Service Campaign Bulletin

Campaign No. 2012080004, November 2012

SUBJECT: **Model 221 (S400 Hybrid), Model Years 2010 - 2012**
Check the Power Electronics Module, Replace if Necessary

Figure 1

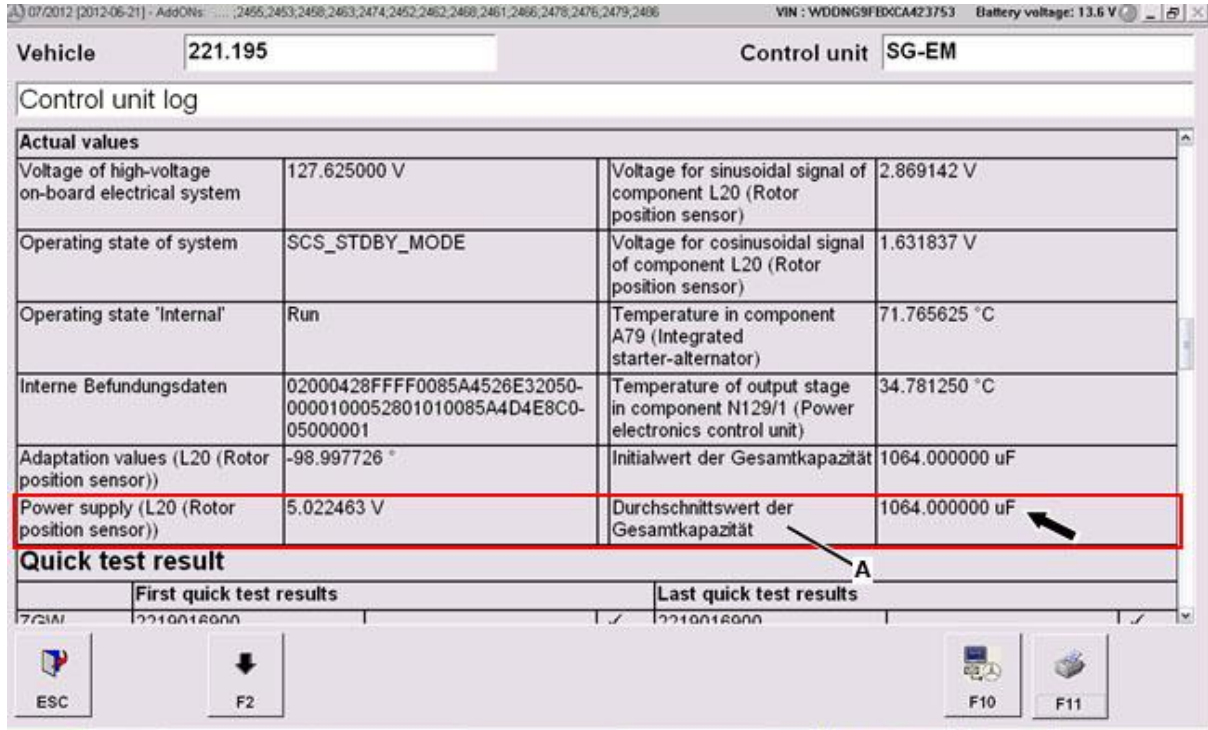
- This procedure (step 3) is to be repeated **six times**.
 - Then perform "Control unit reset" (can be found under Actuators).
4. Create SG-EM control unit log (this operation step is mandatory for the data transfer):
Select menu item "Control units / Drive / SG-EM Electric motor control unit / Control unit log" and create control unit log.
 5. Assessment of total capacity in power electronics module:
Read out value "Average value of total capacity" in SG-EM control unit log.
To do so, in electric motor control unit under "Current values" read off the value "Average value of total capacity" (arrow, Figure 1 [in screen display] and see also Figure 2 – field no. 088 [in control unit log print out]).

If the average value "0" is shown, the test sequence has not been completed successfully. The measurement (step 3) is to be performed here until a value greater than "0" is displayed.

- If average value is **equal to/greater than 800 uF (OK): Procedure is complete.**
- If average value is **less than 800 uF (NOT OK):** Proceed to subject **B**.

- The text in SDS is written partially in German (A, Figure 1) in the screen print below:
 "Durchschnittswert der Gesamtkapazität" this translates to: "Average value of total capacity".

Figure 2

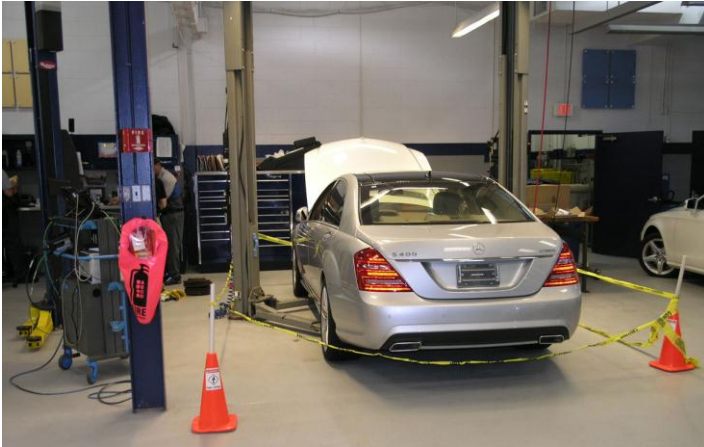
- Secure work area with high voltage warning tape and cones (Figure 2).
- Follow all safety precautions and notes in above WIS instructions.

Figure 4

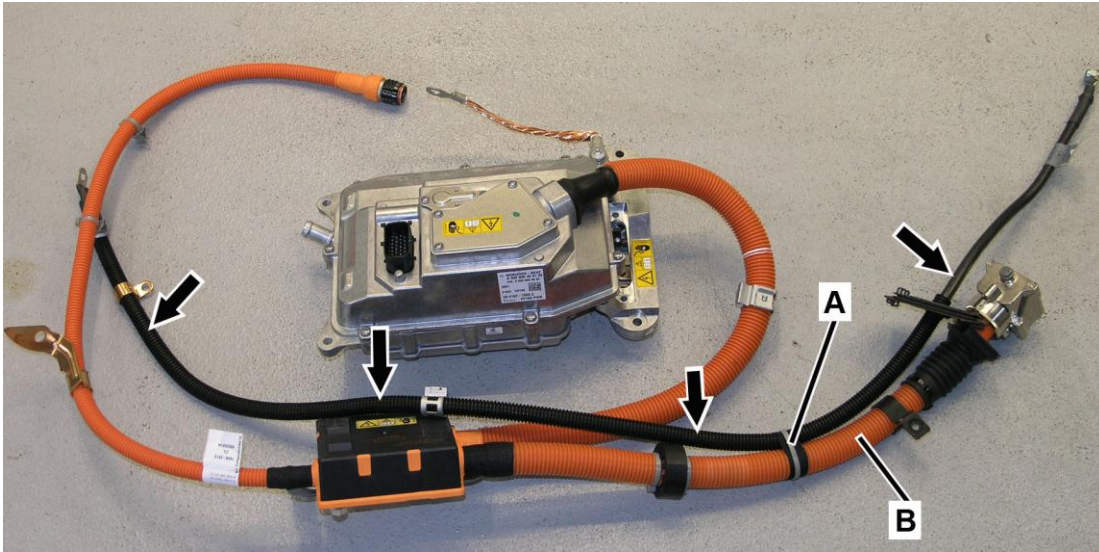
- Do not remove the existing alternator cable (arrows, Figure 4) from vehicle when removing power electronics module. Cut cable tie (A) to detach existing alternator cable (arrows) from old power electronics cable (B) and leave existing alternator cable (arrows) on vehicle
- Prior to installing **new** power electronics module, cut cable tie (A, Figure 4) and remove **new** alternator cable (arrows) attached to **new** power electronics module cable (B). The **new** alternator cable (arrows) does not get installed on vehicle.

IMPORTANT: Secure original alternator cable (arrows) to same position on **new** power electronics cable (B) with **new** cable tie (A) after installing power control module. Be sure to use **only** the cable tie listed in parts table.
